DEPARTMENT OF THE AIR FORCE
AIR FORCE CIVIL ENGINEER CENTER

Subject: Response to Need for Continued Extraction for Containment
Site ST012 - Former Williams Air Force Base (AFB), Mesa, Arizona

Attachment 1
Responses to EPA/ADEQ Joint Letter – Need for Continued Extraction for Containment at ST-12 Fuels Spill Site, Former Williams AFB, Mesa, AZ

Attachment 2
Responses to EPA April 29, 2016 email questions

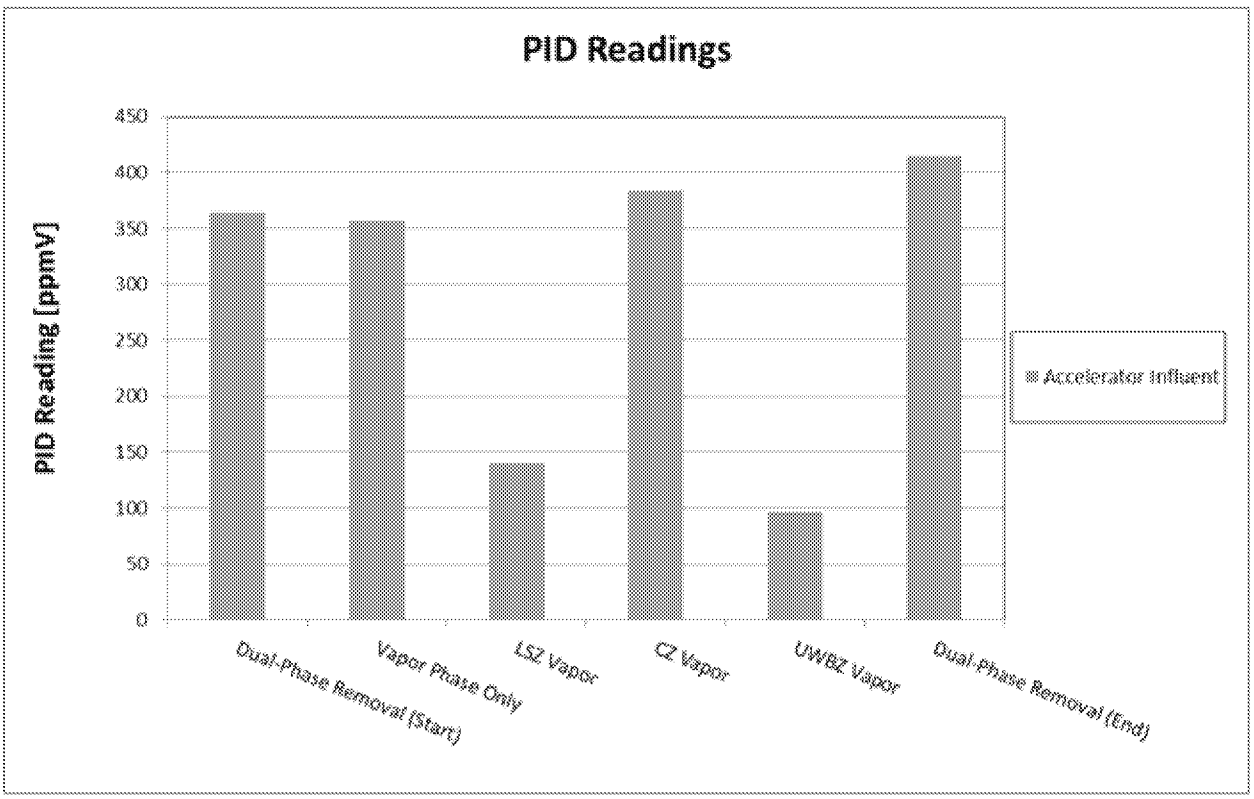
b. "The contaminant sources for the recent vapor mass recovery (dissolved phase and volatilized contaminants in extracted steam or air) are likely masses of residual LNAPL remaining in the TTZ (and other soil volumes previously heated to steam temperature)."

Response: In the last week of post-steam extraction, a study was conducted to evaluate where the vapor mass was originating. The extraction system was sequentially operated through a sequence to isolate each zone and take PID and flow rate measurements. Time was provided (approximately 45 to 60 mins) to allow flushing of the vapor system. The sequence of tests was as follows:

A graph presenting the PID readings at the thermal accelerator influent is provided below.

This data indicates that the CZ is contributing most of the mass in the vapor phase since the vapor mass removal rate when only the CZ was open to extraction was close to the mass removal rates during normal operations (vapor and liquid extraction) and vapor only extraction from all three zones. This observation is consistent with previous technical explanations because this zone has more open screen for vapor extraction available and vapors extracted through this zone would, in part, capture mass from the vadose zone (such as the deep vadose zone intervals addressed by the deep SVE well screens). This observation is not consistent with the agencies suggestion that masses of residual LNAPL within the TTZ are the likely primary source of vapor mass recovery. However, as discussed below, SEE wells will be checked and monitored for LNAPL.

It should be noted that some mass removal is observed in the vapor phase for both the UWBZ and the LSZ tests. This mass removal is likely due to the lack of complete isolation of those zones during the tests. If open screen is not available in either the UWBZ or the LSZ, isolation on one of those zones may encourage leakage at other wells that have been shut off but are all connected to the same piping manifolds.

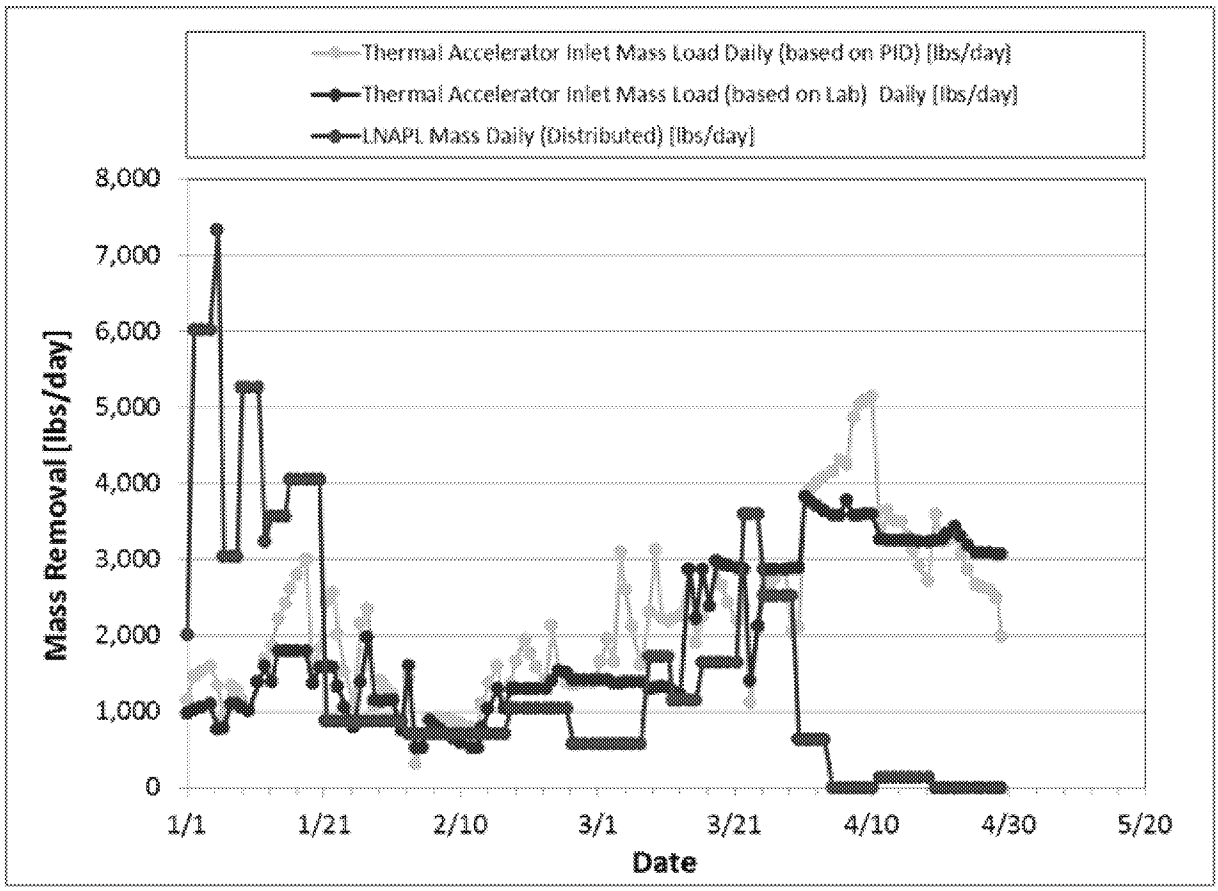
c. "LNAPL columns likely reside in extraction well casings. The bottom of such LNAPL columns may exist above the pump intakes because of limited drawdown and therefore LNAPL does not appear in jar tests. This LNAPL is not recovered by pumping but can supply vapors for extraction. If so, the persistence and increase in vapor mass recovery indicates this LNAPL is being replenished from a "reservoir" of NAPL around such extraction wells. If the bottom of the LNAPL column is below the top of the screen intervals it is hydraulically connected to the formation for replenishment. Recent mass vapor extraction rates exceed the equivalent of 300 gallons/day of LNAPL. Each casing has a capacity on the order of 50 gallons therefore, if this LNAPL is the source of extracted vapors, the formation is replenishing the LNAPL in the casing as fast as it is removed. The drawdown increased with the cessation of steam injection and likely contributes to the increased vapor recovery rate. If the water levels in the extraction wells are allowed to rise, the vapor mass recovery will likely diminish. That reduction will not be the result of LNAPL remediation but rather hydraulically disconnecting residual LNAPL in the formation from vapor extraction."

Response: While LNAPL volumes could exist in well casings, this is a conceptual explanation for the vapor mass recovery that doesn't have any direct measures to verify it. SEE wells are in the process of being opened and checked for the presence of NAPL layers. If NAPL is present, the wells will be included in routine NAPL monitoring/removal activities. The recent testing described above suggests that the CZ is the primary source of vapor mass. Further, the significant increases of vapor mass removal during depressurizations are delayed from the drawdown associated with depressurization (see mass removal graph below, with depressurizations between 28 December to 21 January, 5 February to 18 February, and 4 March to 29 April), which would not be consistent with an LNAPL reservoir in close proximity to the well casing.
